From: Neil Duffield
Sent: 12 July 2022 09:49
To: Hilary Saunders <
Cc: lou
Subject: 22/0249 Low Farm, Sneaton E11107-41Nymnp info 12-07-22

From: Hilary Saunders
Sent: Tuesday, July 5, 2022 3:59 PM
To: Neil Duffield
Subject: 22/0249 Low Farm, Sneaton

From: Mark Antcliff
Sent: 09 June 2022 12:05
To: Planning
Subject: NYM/2022/0249 Low Farm, Sneaton

PROJECT: **Low Farm Sneaton**

DRAWING No: **D11107-05** REV: **G**

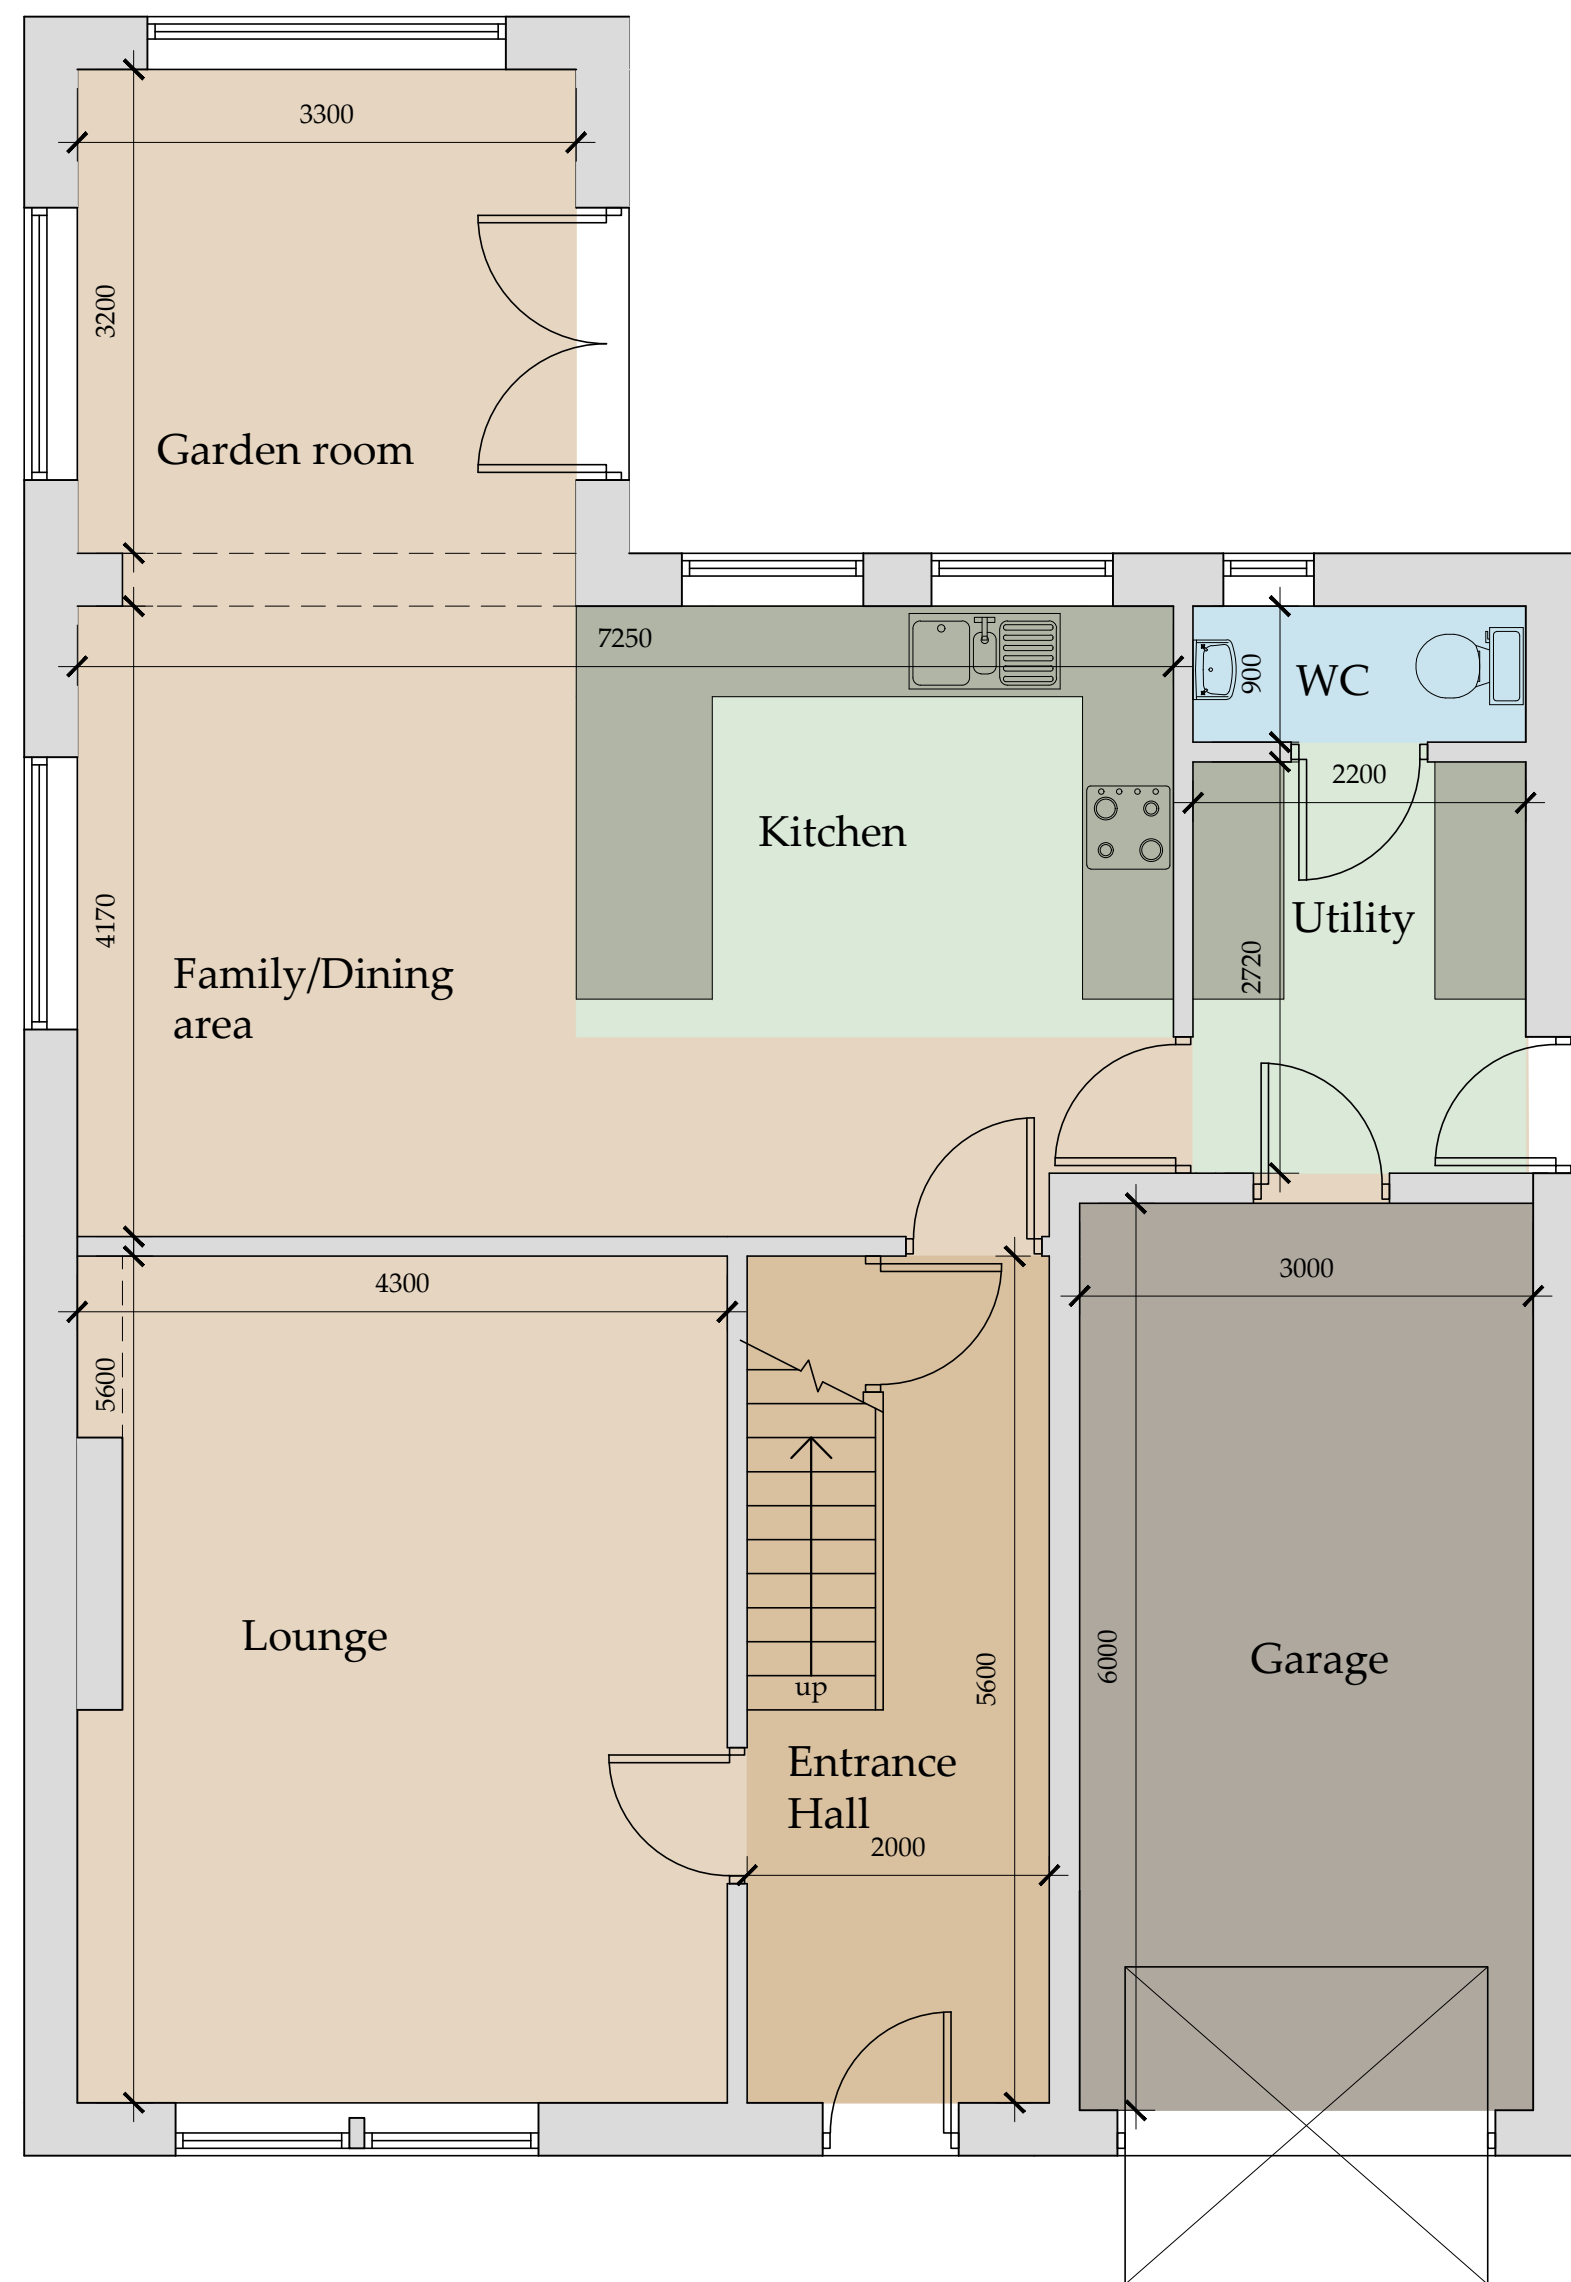
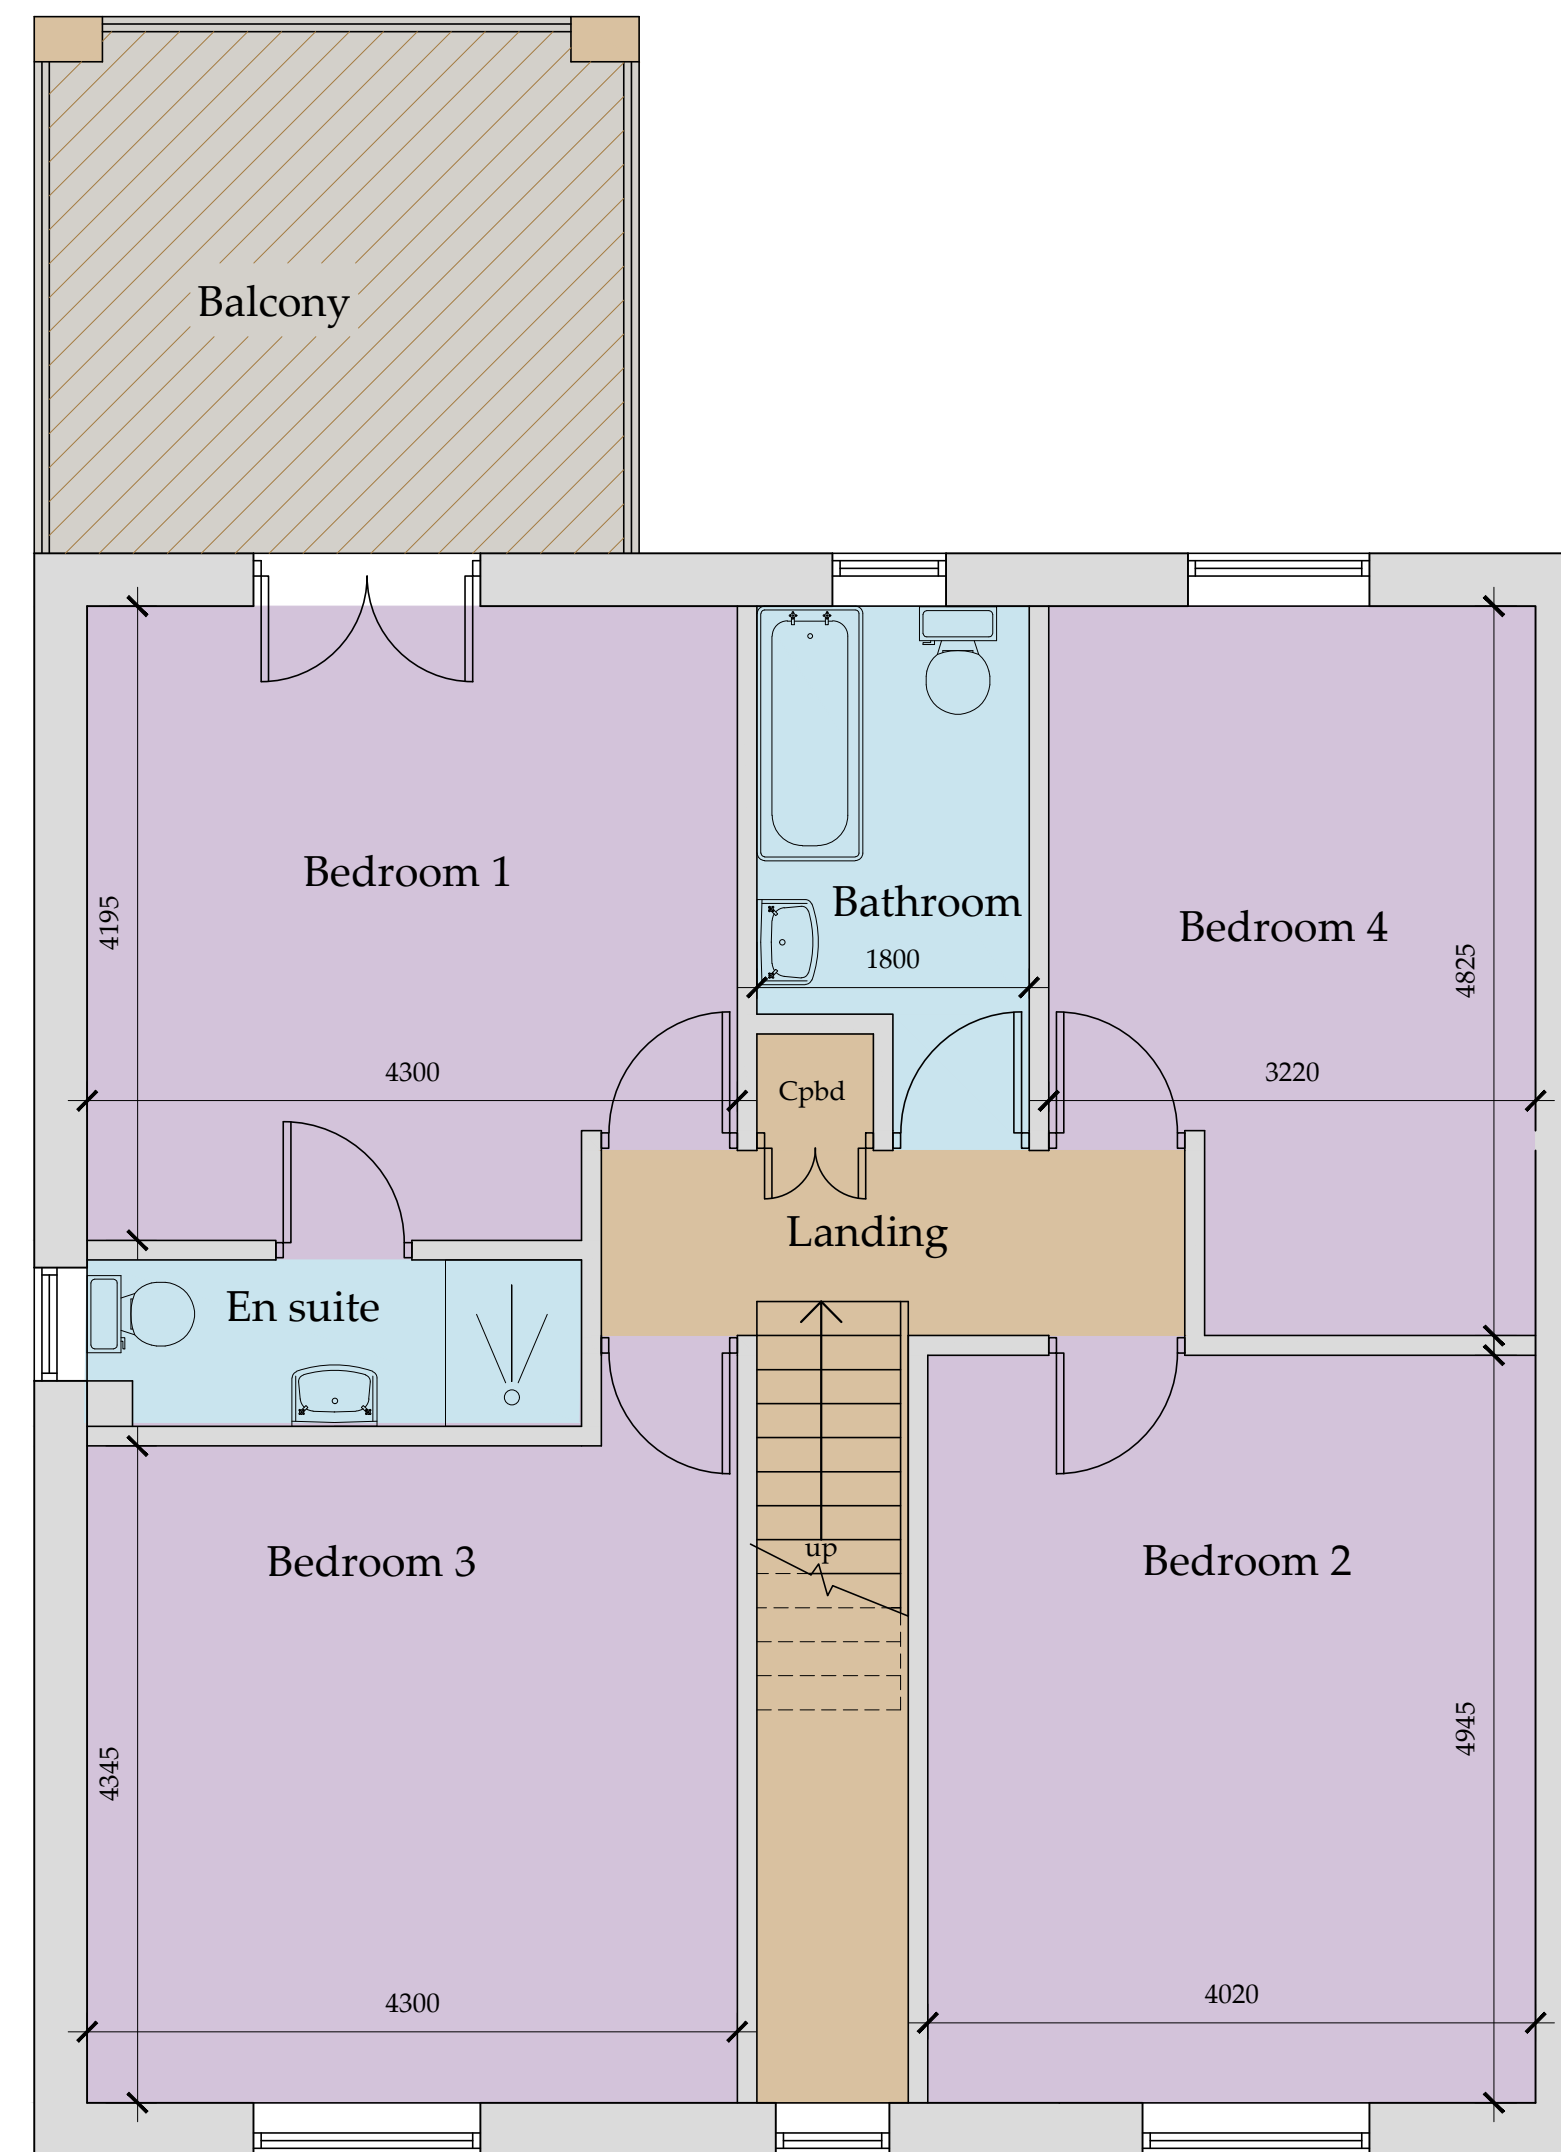
- The balcony to plot 1 is hard up against the boundary of plot2 could the inside layout be handed so the balcony was next to the field access rather than so close to the neighbour.

4. The rear extended areas to plots 1 and 2 are both located to suit the orientation of the sites. The closest window on Plot 2 is the Kitchen window (apart from the WC). This is almost 5m from the Plot 1 wall, 4.1m from the boundary. Generally we would feel this was within the design guide requirements. Additionally there is a 1.8m translucent glazed panel on the boundary side of the Terrace.

G	11/07/22	CE	Anotate glazed screen
F	08/06/22	CE	Solar panels added
E	07/06/22	CE	Amended to suit planning
D	08/03/22	CE	Lintels added
C	21/02/22	CE	Amended to suit client
B	03/12/21	CE	Amended to suit client
A	01/10/21	CE	Issued for approval
